Development Permit Panel

Wednesday, November 29, 2017
3:30 p.m.

2. **DEVELOPMENT PERMIT 16-741741**
(REDMS No. 5610624 v. 2)

That a Development Permit be issued which would permit the construction of a Marine Terminal Facility for aviation/jet fuel delivery at 15040 Williams Road on a site zoned "Industrial (I)" and partially designated as an Environmentally Sensitive Area (ESA).

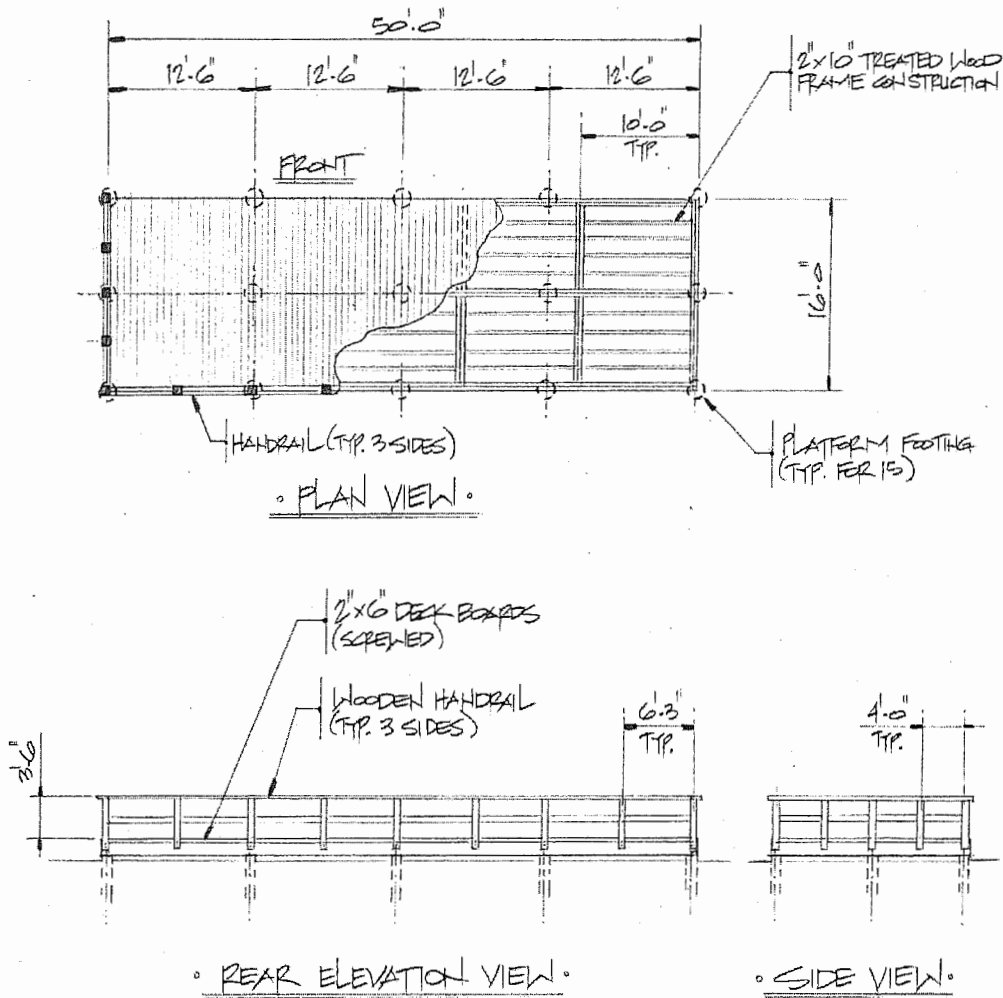
Panel Comment: ***That staff review the adequacy of the pedestrian viewing platform cash-in-lieu contribution and report back.***

Staff Response: A detailed cost breakdown for the proposed observation platform (refer to Attachment D), as provided by the applicant's contractor, has been reviewed by Parks Department staff.

The design is essentially a short treated wood frame construction platform with a protective wooden handrail at its perimeter. The platform will sit atop wood footings to provide an overlook to the Fraser River and would be similar to observation platforms used in various locations in Richmond. The platform would not be intended to project out significantly from the dike and would not extend past the high water mark. The basic design is shown in Attachment D.

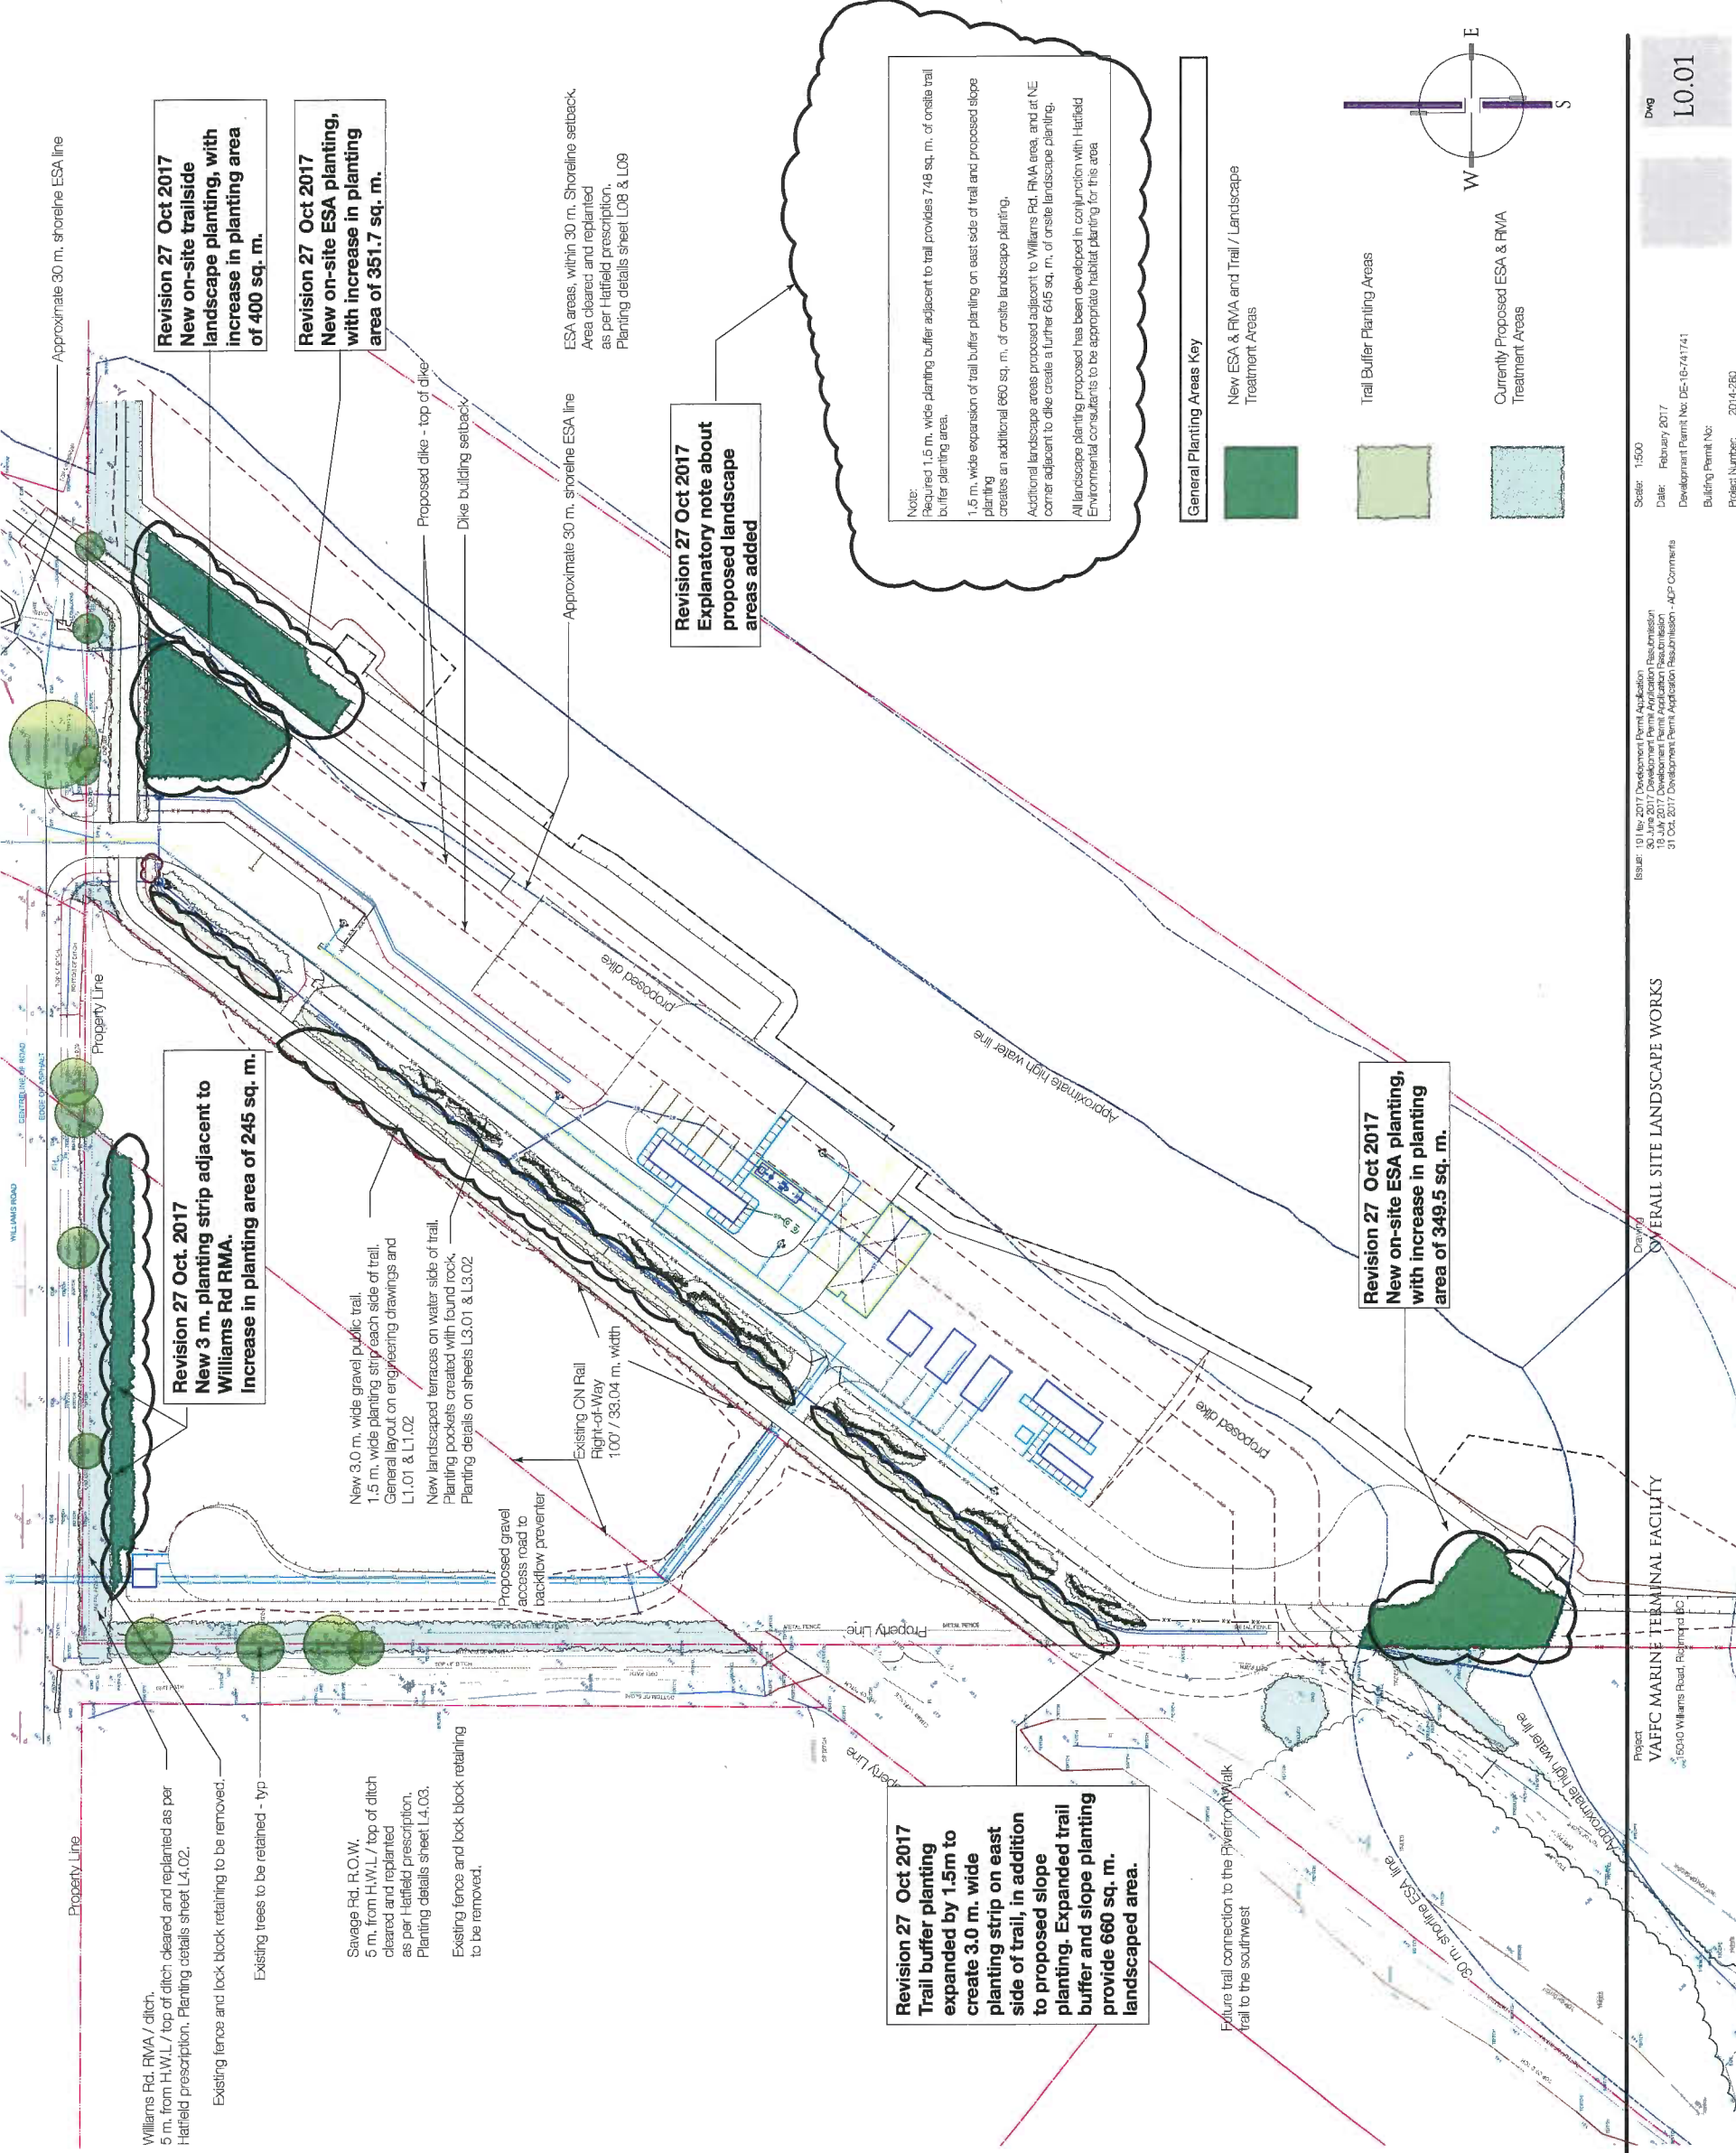
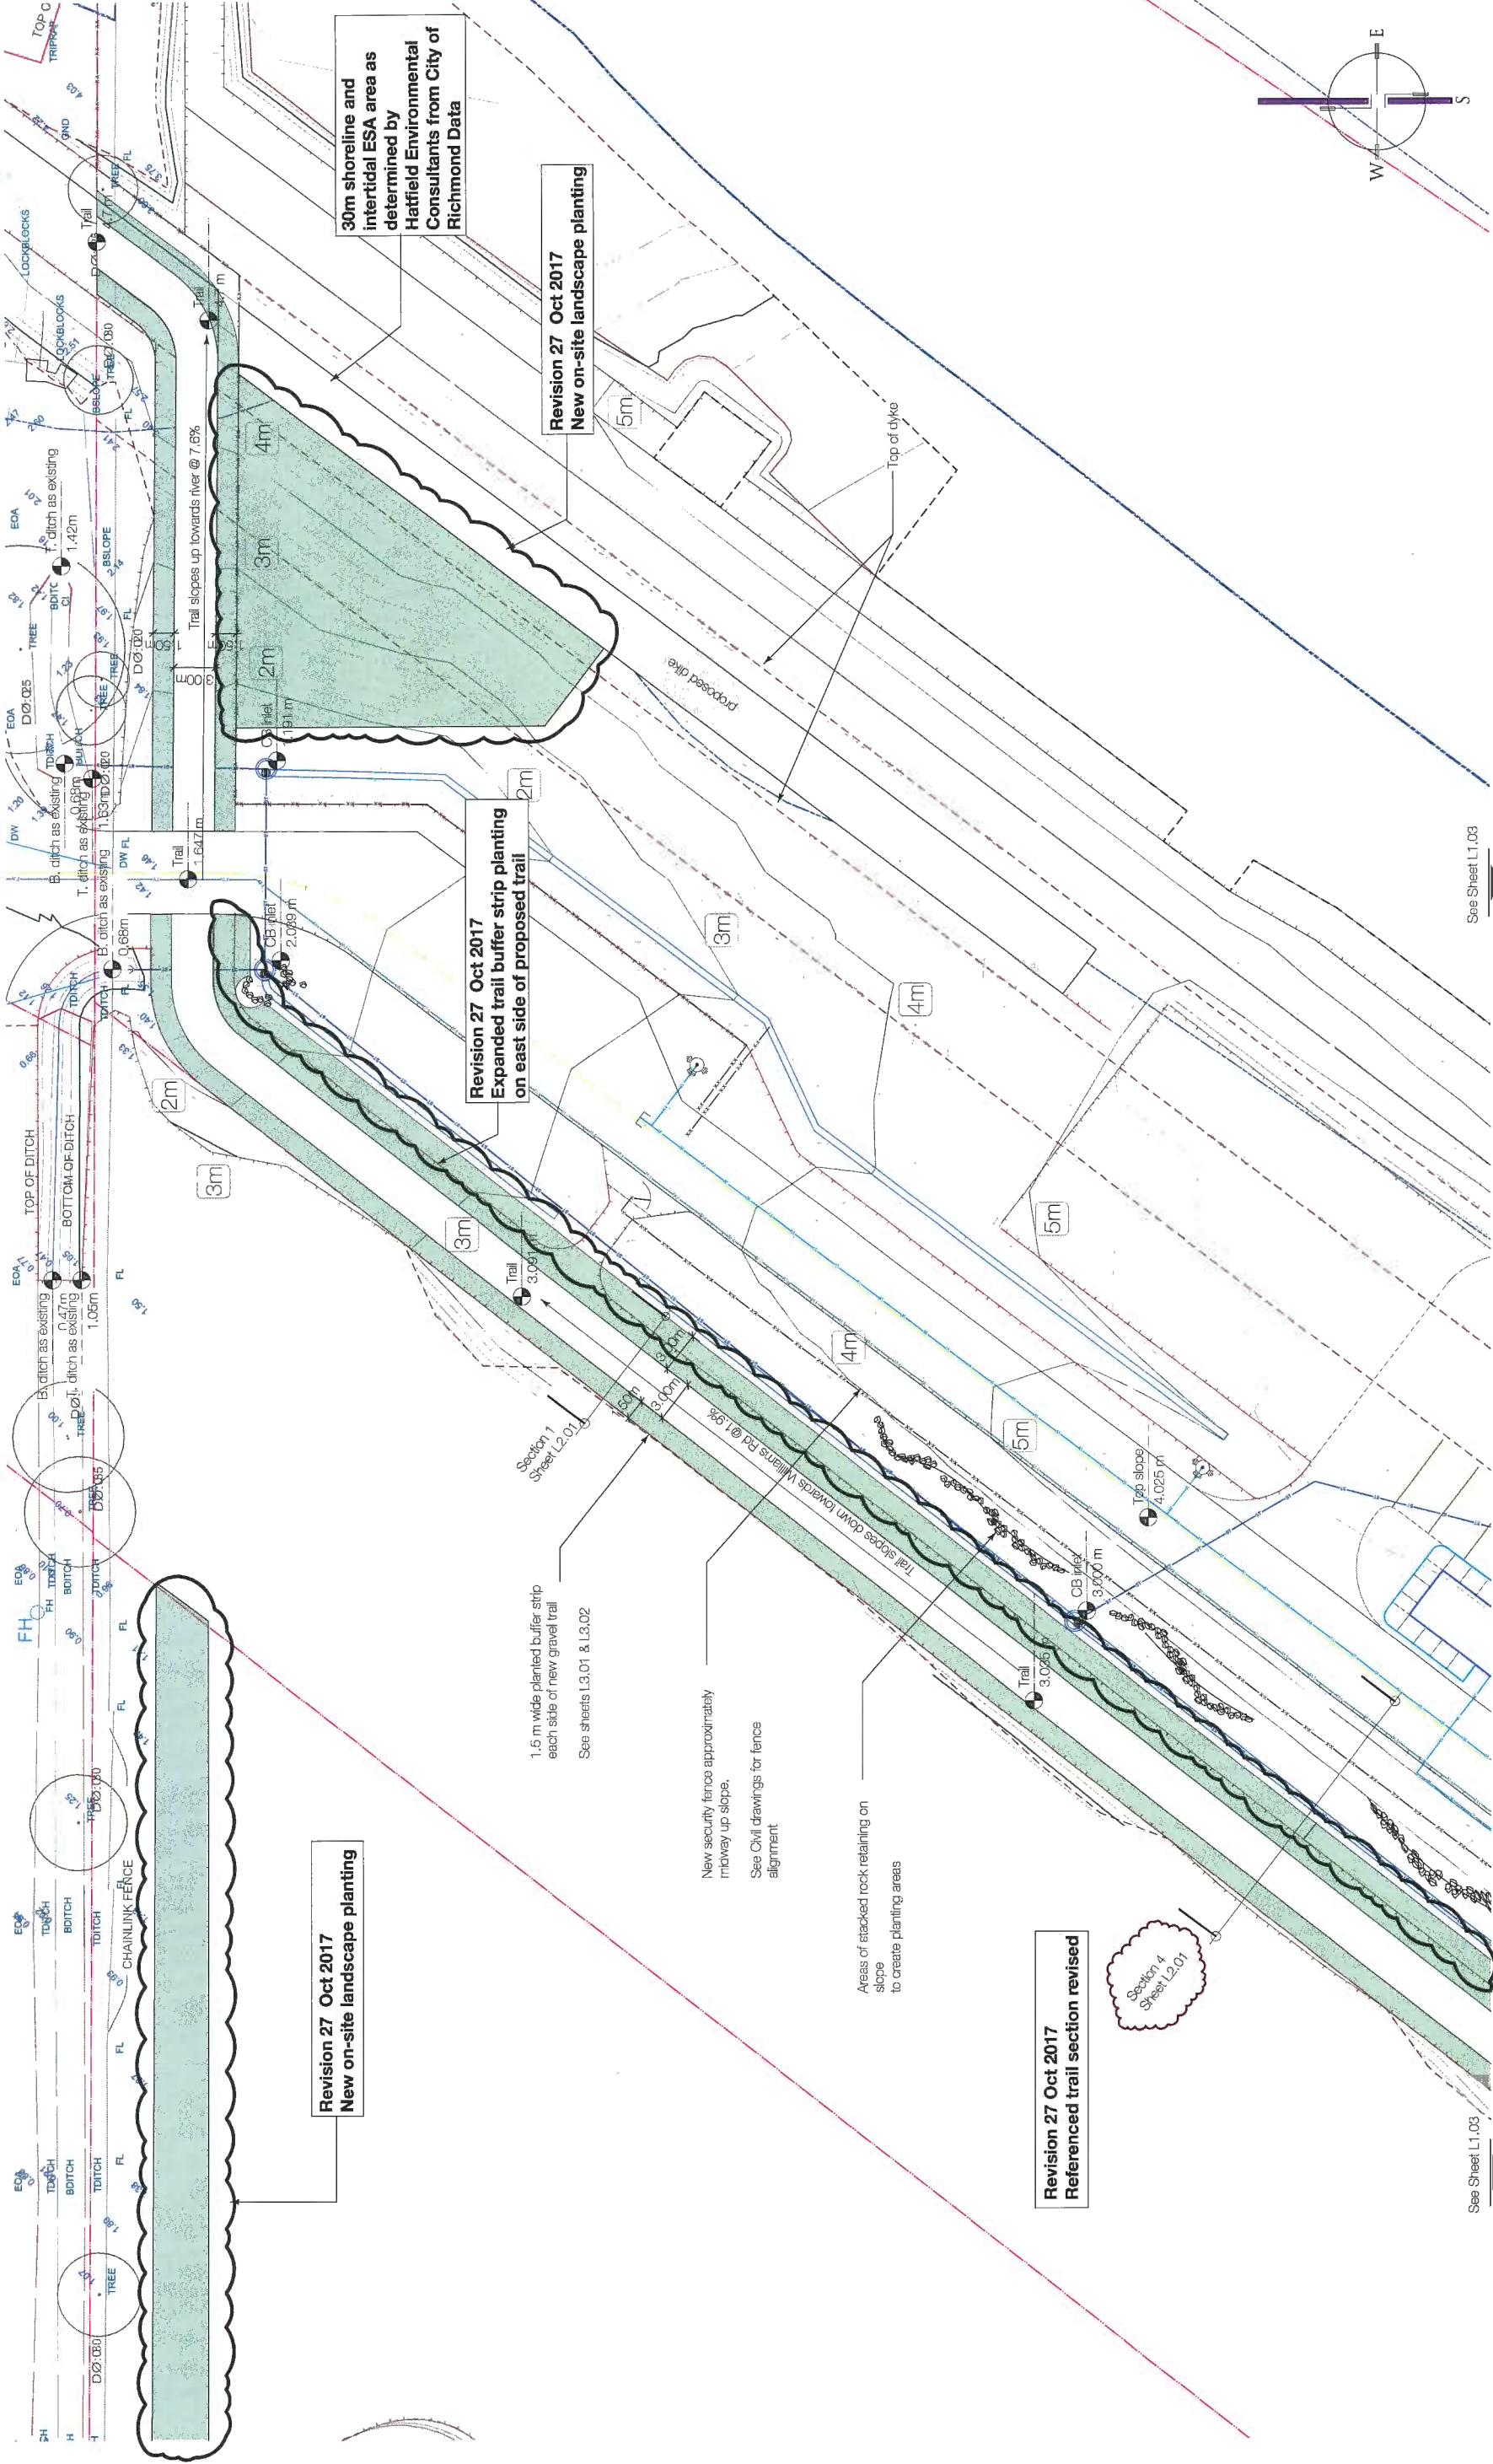
Panel Comment: *Review the proposed mitigation, compensation and enhancement scheme for shoreline ESA based primarily on existing ESA condition in the subject site and investigate opportunities for additional on-site ESA planting.*

Panel Comment: *Review the proposed compensation/enhancement planting scheme for the shoreline ESA and consider introducing more mature and substantive planting.*

Panel Comment: ***Investigate opportunities for further on-site ESA compensation and enhancements especially within the shoreline ESA and other areas along the proposed public trail and in the northern portion of the site in addition to the proposed off-site ESA enhancements.***

VAFFC Response: “Additional ESA compensation areas totaling 702 m² (7,556 ft²) have been added in the northeast and southwest extents of the site.”

The VAFFC response provides two new shoreline ESA planting areas to the site plan (refer to Plan #15). The first is a new 352 m² shoreline ESA planting area with additional trees, shrubs and herbs at the southwest corner of the site. The second is a new 350 m² shoreline ESA planting area with short shrubs and herbs at the northeast corner of the site.

VAFFC Response: “New ESA compensation areas include some larger plants, as well as new landscaping areas outside of the ESA.”

The VAFFC’s revised planting plan increases the pot sizes primarily for the coniferous trees in the Shoreline ESA. They’ve advised that the deciduous trees are better planting in smaller sizes but higher concentrations to out compete invasive species. Larger trees (both coniferous and deciduous) have also been incorporated within the non-ESA/non-RMA planting areas.

VAFFC Response: "VAFFC has offered further enhancement of upland areas adjacent to the public trail and along the Williams Road Riparian Management Area (RMA). Additional areas totaling 645 m² (6,943 ft²) have been added which brings the total landscaping commitment to approximately 2,053 m² (22,098 ft²)."

Three additional non-ESA/non-RMA planting areas are proposed by the VAFFC. The first is a new trailside area in the northeast corner of the site. The second planting area involves a new 3 metre wide strip adjacent to the Williams Road RMA. The third area is a 1.5 m widening of one side of the proposed vegetation planting strip adjacent to the public trail.
